ARCHITECTURAL REVIEW BOARD WORK SESSION AGENDA

Agenda Item: APPLICATION FOR NEW CONSTRUCTION, ARB #25-001, to consider an application for the construction of a new restaurant, Pollo Campero, with a drive-thru, located at 1131 Elden Street, Herndon, Virginia. [Continued from the March 19, 2025, regular meeting pursuant to ARTICLE IV. MEETINGS, paragraph a. of the ARB Bylaws.]

Prepared by: Bryce Perry, Deputy Director of Community Development

DRAWING TITLE:
REVIEW ELEVATIONS

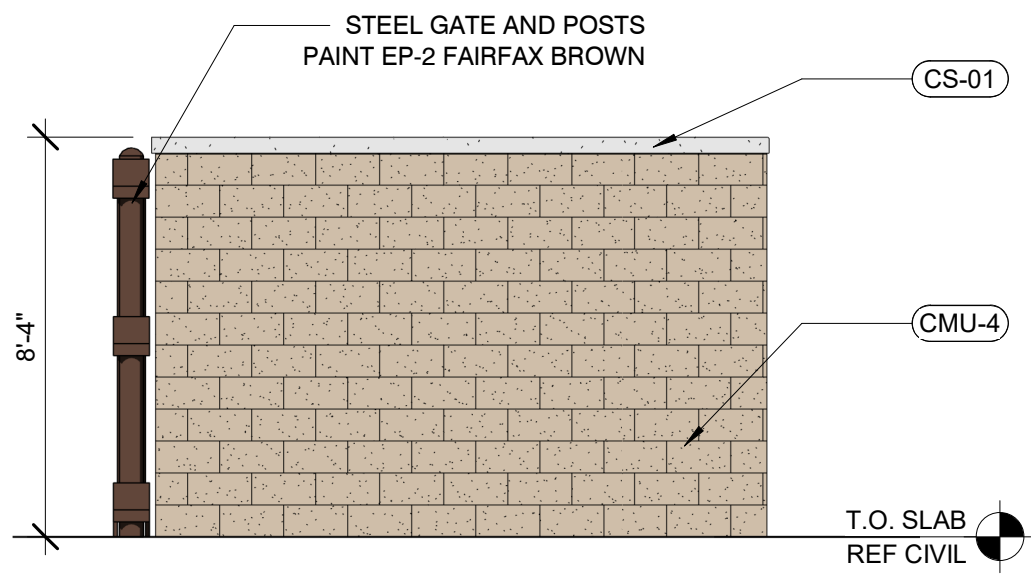
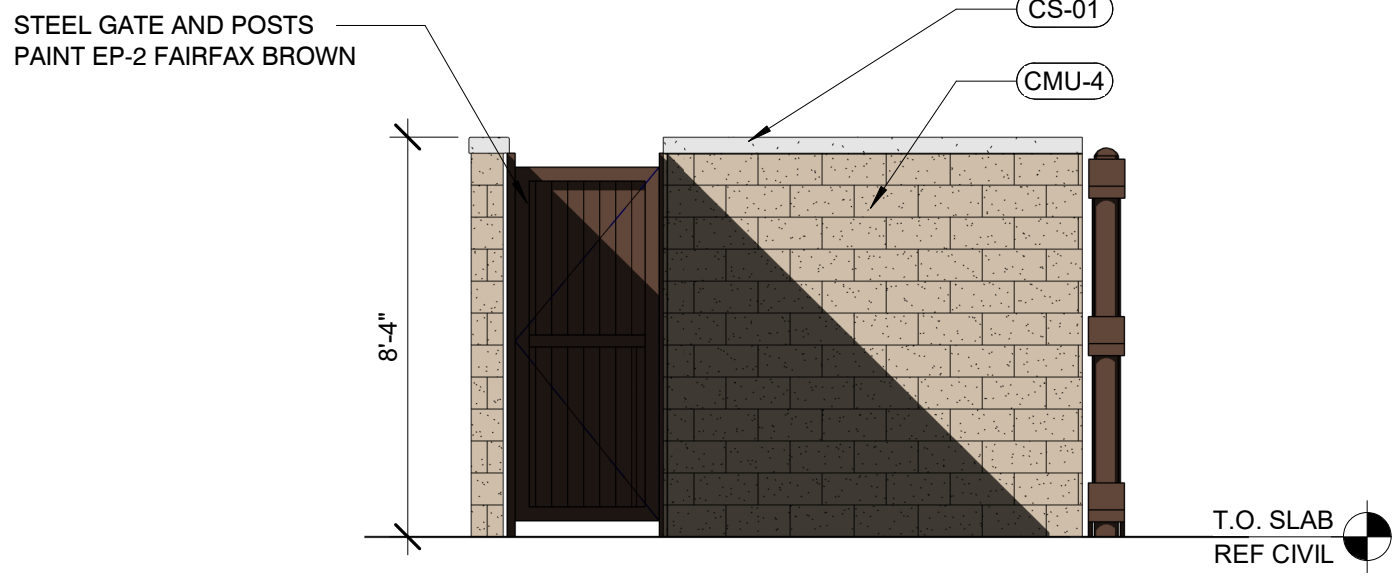
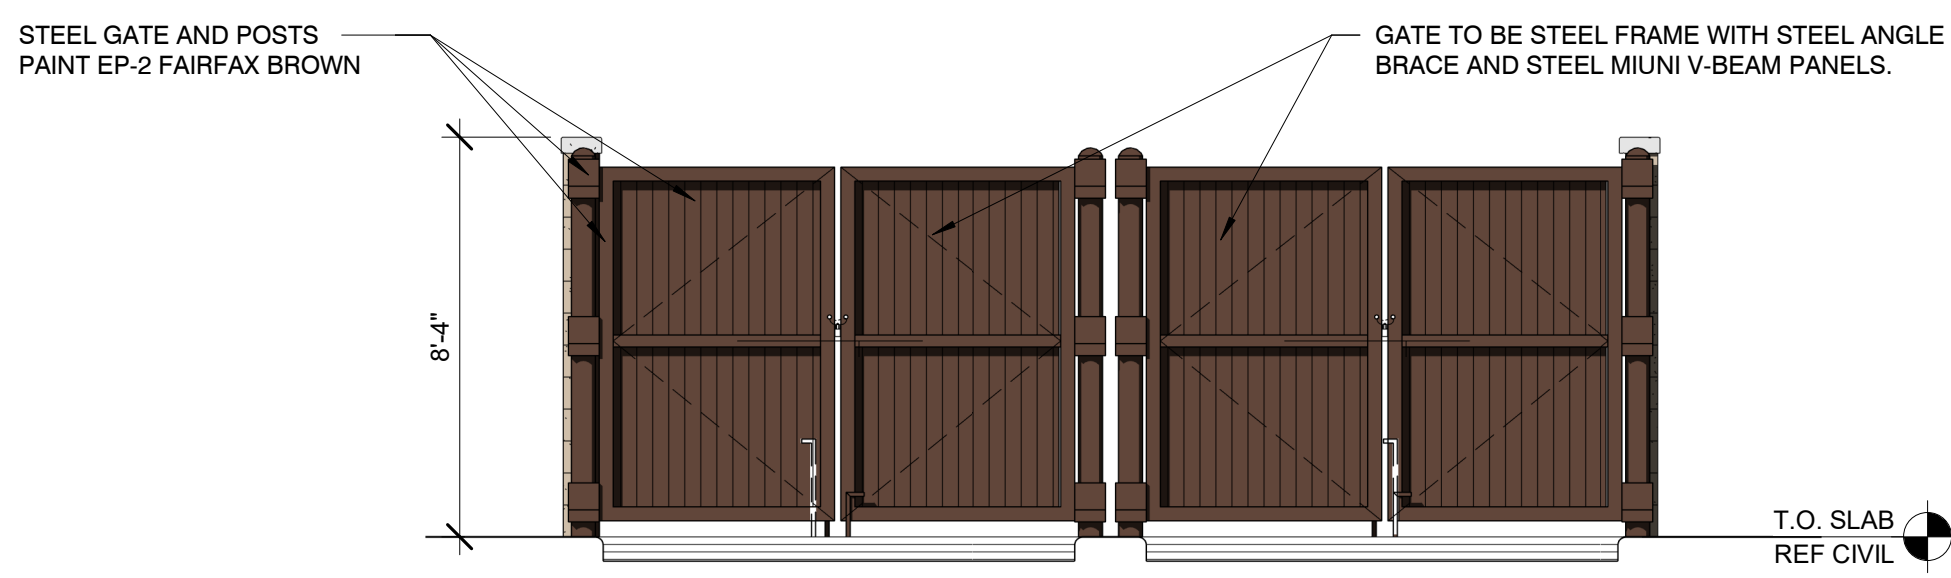
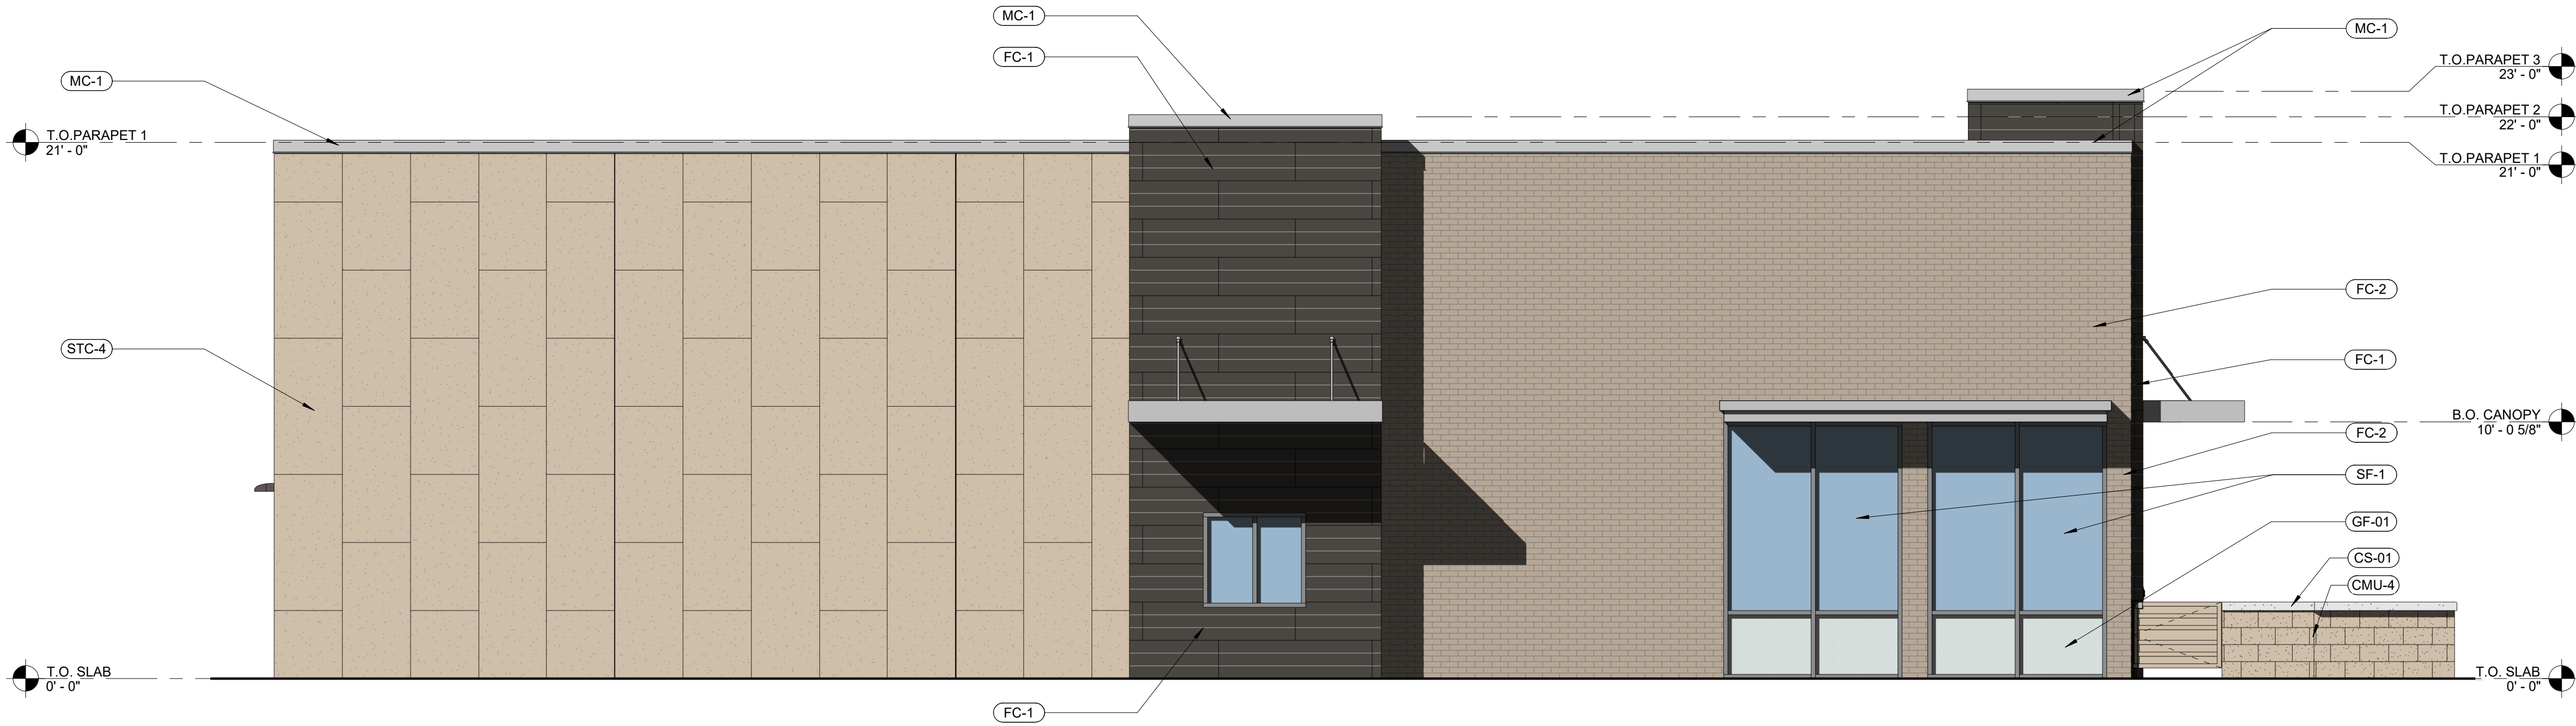
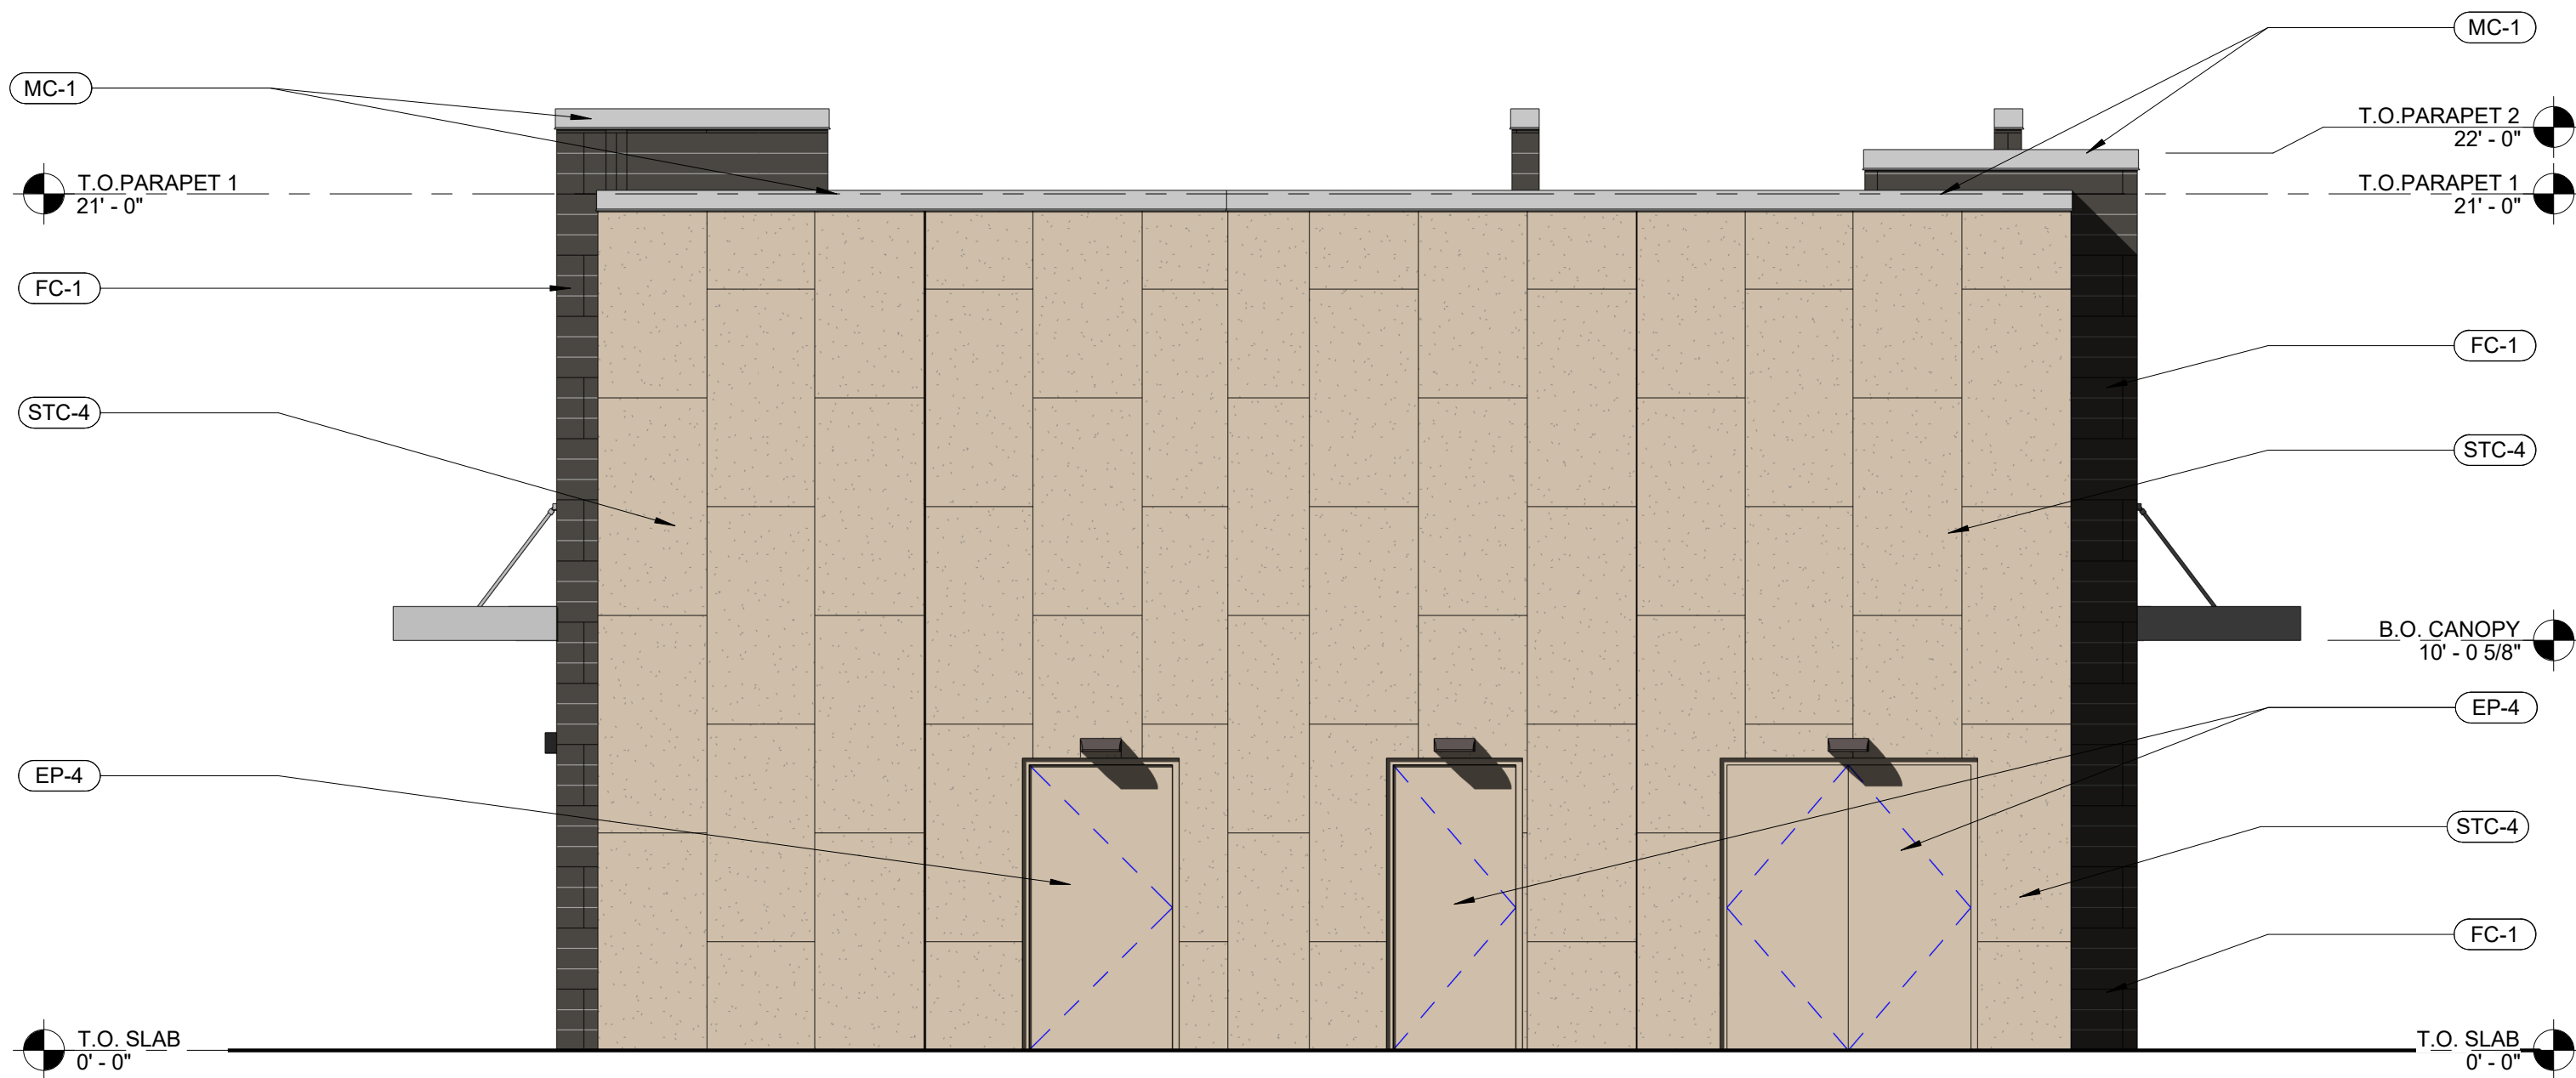
1. Revisions. The updated drawings are responsive to the comments expressed to date. The design has been simplified with less diversity in exterior materials, a panelized brick material has been introduced as the primary material on the front half of the building, and the tower accent forms have been carried through to the ground and have much deeper returns at the roofline.

2. Use of the STO Powerwall Synthetic Stucco System. This EIFS product is used exclusively on the back half of the building as the cladding material. Overall, it remains as the most used exterior material. EIFS has been generally discouraged for use as a principal exterior treatments in the Architectural Control District. Issues regarding material and aesthetic durability are often cited. The foam-based system does have known longevity issues and often the finishes and arrangement of panels create an overly flat appearance. The product does offer a range in finishes which can mimic anything from a cement coat to precast concrete and how it is panelized can have significant impact on the texture, scale, and articulation of the wall surface. These details should be fully understood and a good material sample will be important to evaluate.

3. Managing Mass/Scale of Stucco Walls. Regardless of whether it remains EIFS or not, if the back half of the building remains a single cladding material, tactical ways to manage that mass should be explored. Adding a feature such as a few downward sconce lights aligned vertically with the canopy on the side elevations might be a simple way to address the concern.

5. Glass Transparency. Staff has requested a sample of the glass be provided for consideration. The glass should as transparent as possible to allow for good visibility

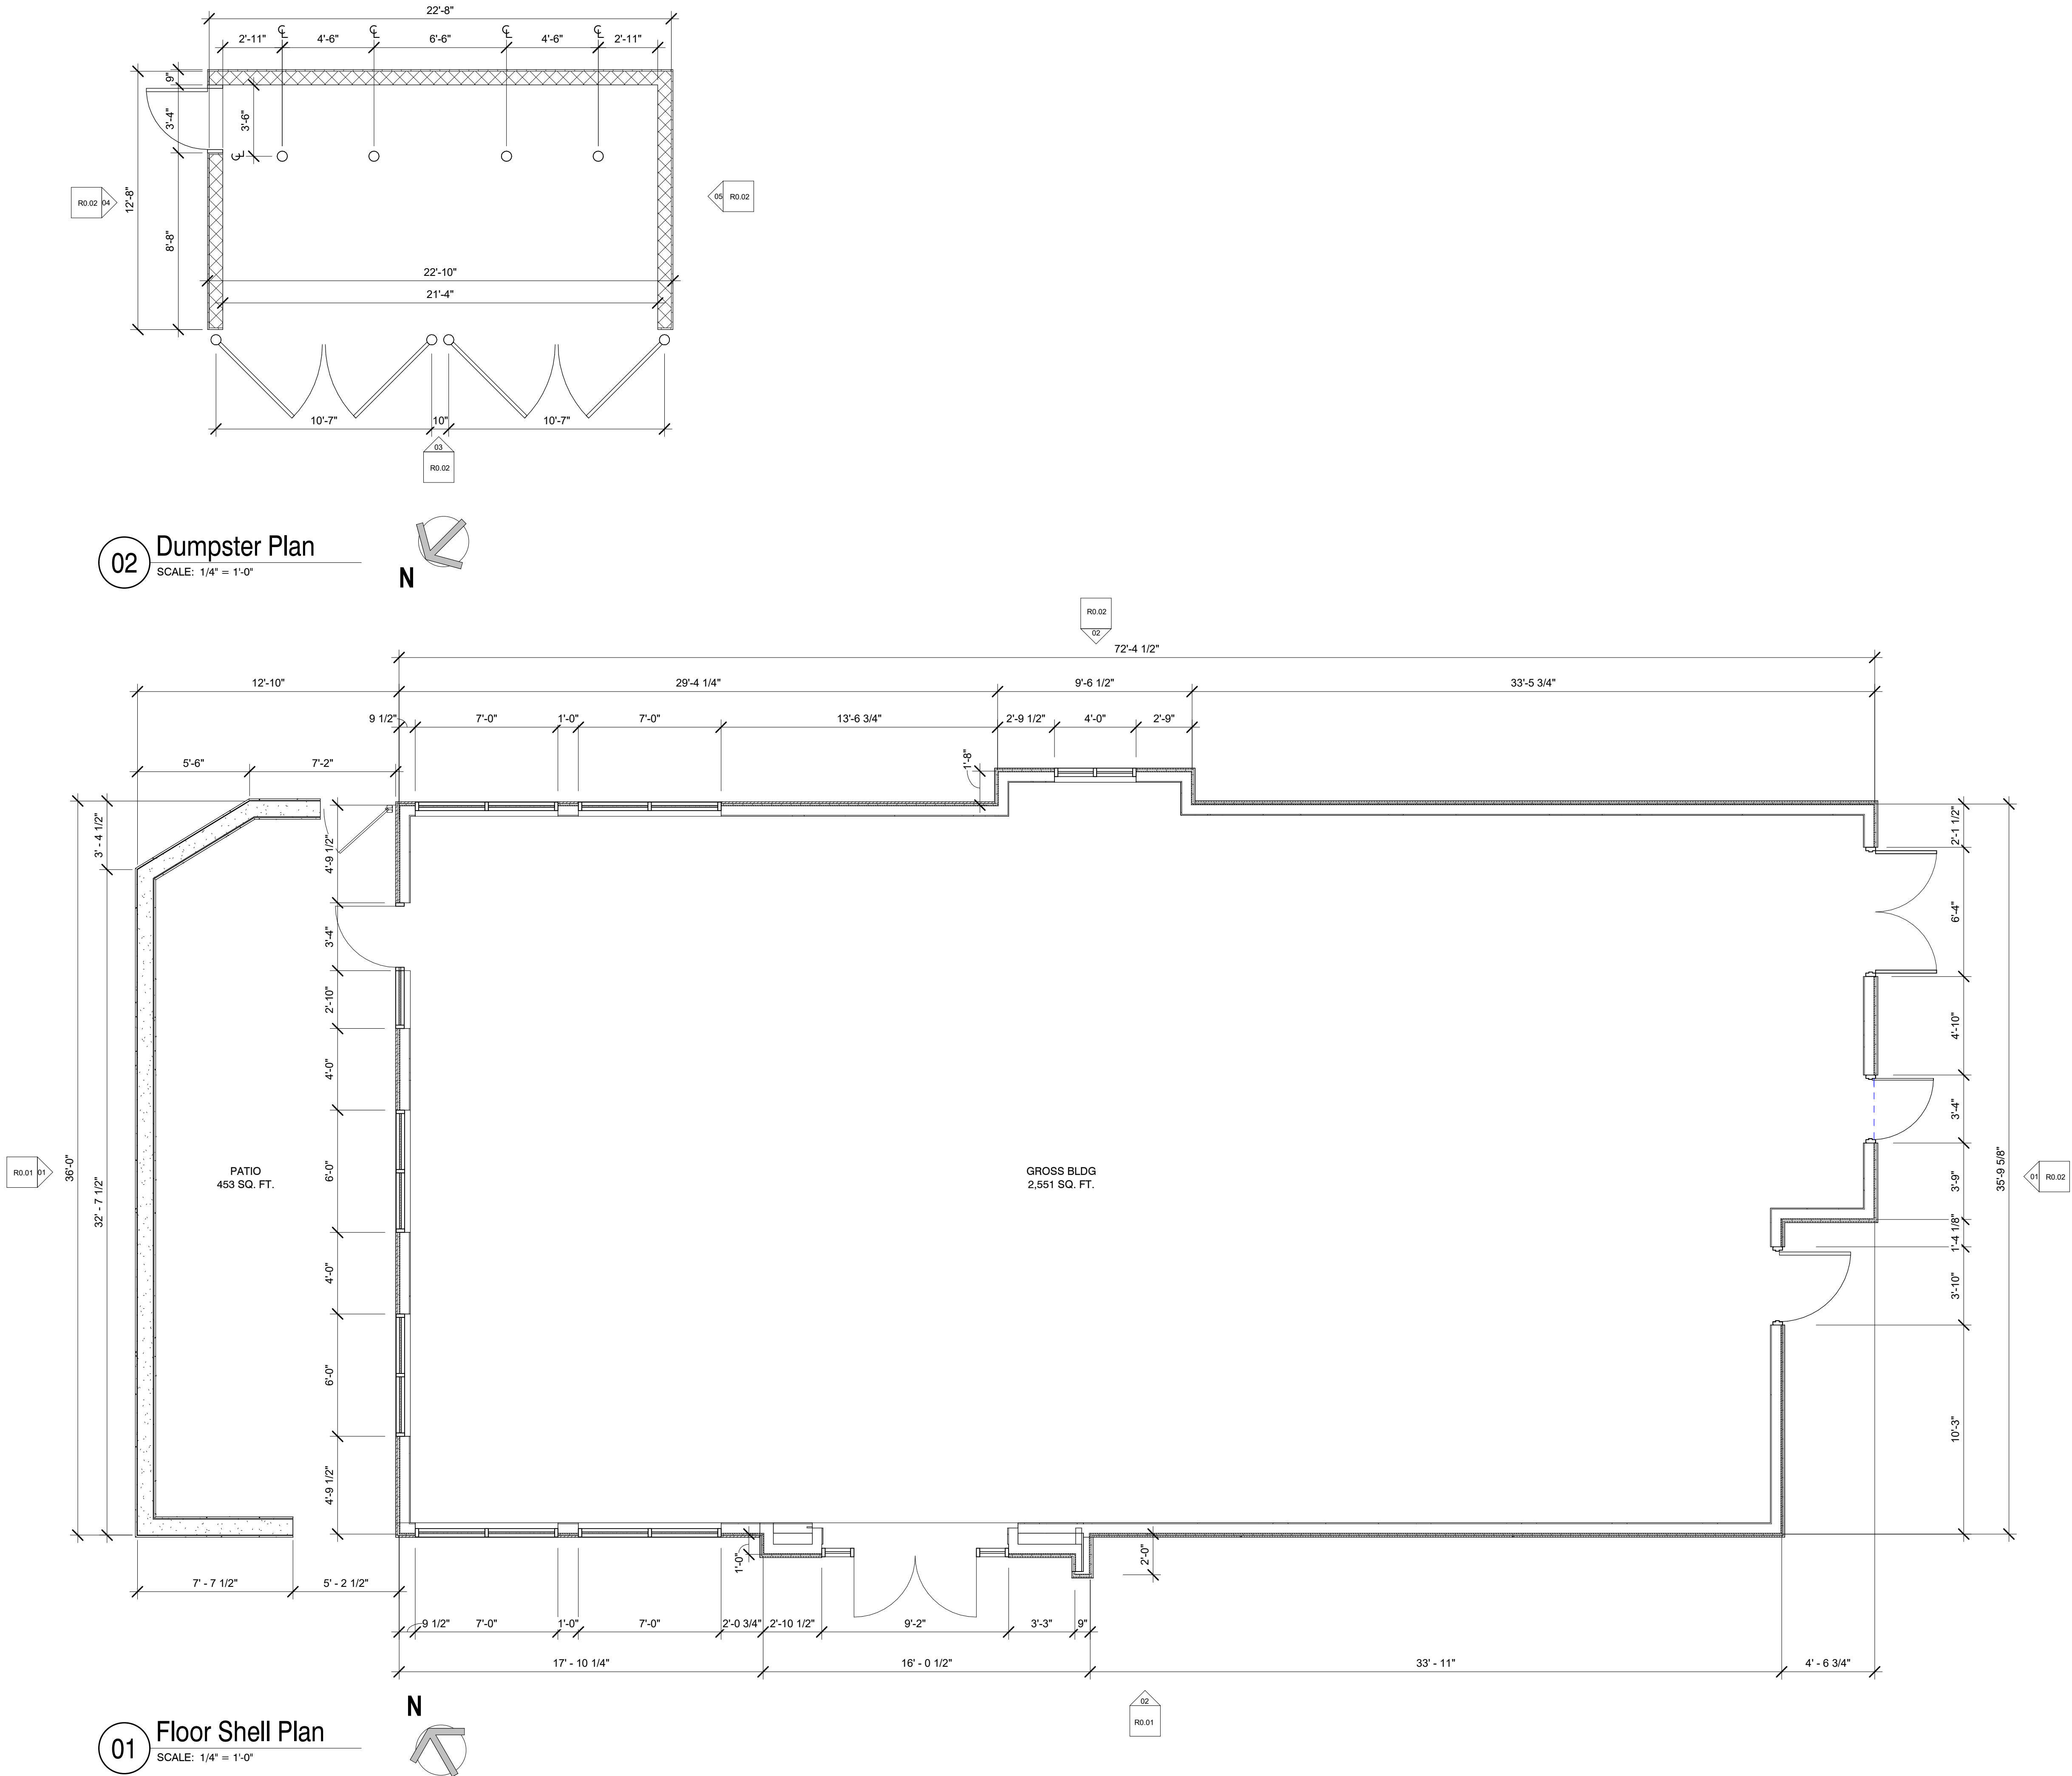
With this design, staff sought design solutions that:

- Bringing the storefront down to the ground to maximize visibility into the restaurant for improved street presence and activation.
